City of Portland, Maine - Building or Use Permit Application

| Location of Construction: 32 Hartley St | Owner Name: Palmer Joan E | Owner Address: 32 Hartley St PORTLAND | Phone: 207-773-8768 |

| Proposed Project Description: Build Handicap Ramp | FIRE DEPT: <input type="checkbox"/> Approved <input type="checkbox"/> Denied | INSPECTION: Use Group: 9-3 Type: 5B PERMIT ISSUED WITH REQUIREMENTS 8/18/01 |

BUILDING PERMIT REPORT

Palmer - ramp

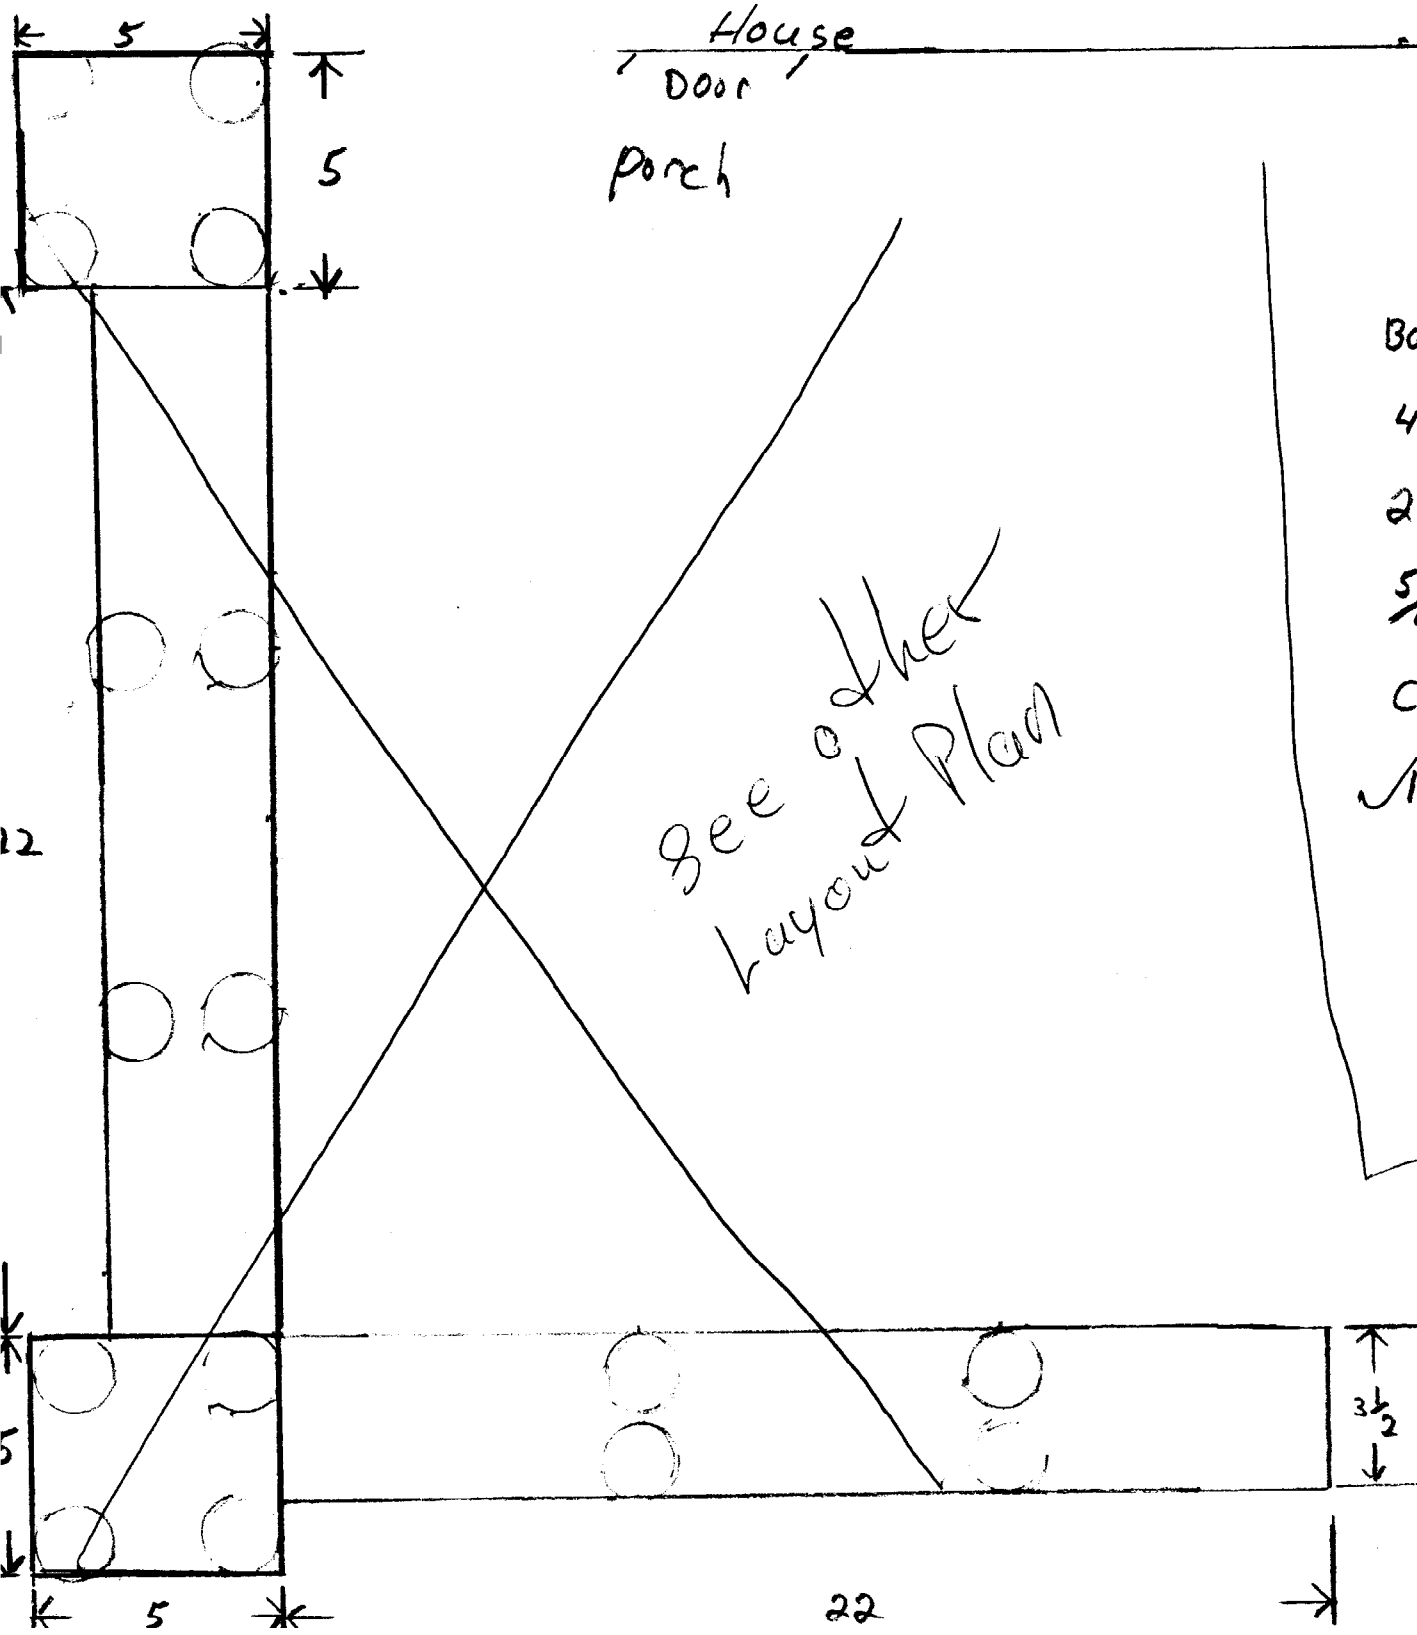
- + 38. *Ramp Construction shall comply with section 1916.0 of the bldg. code. (see attached)*

12. Other requirements of condition: If it is understood that this ramp is needed immediately for access for Mr. Palmer who is shortly being released from the hospital, we are allowing construction based on a follow-up of the owner to come in for zoning Board of approval, the side set back is showing 4 feet instead of the 5' that this office
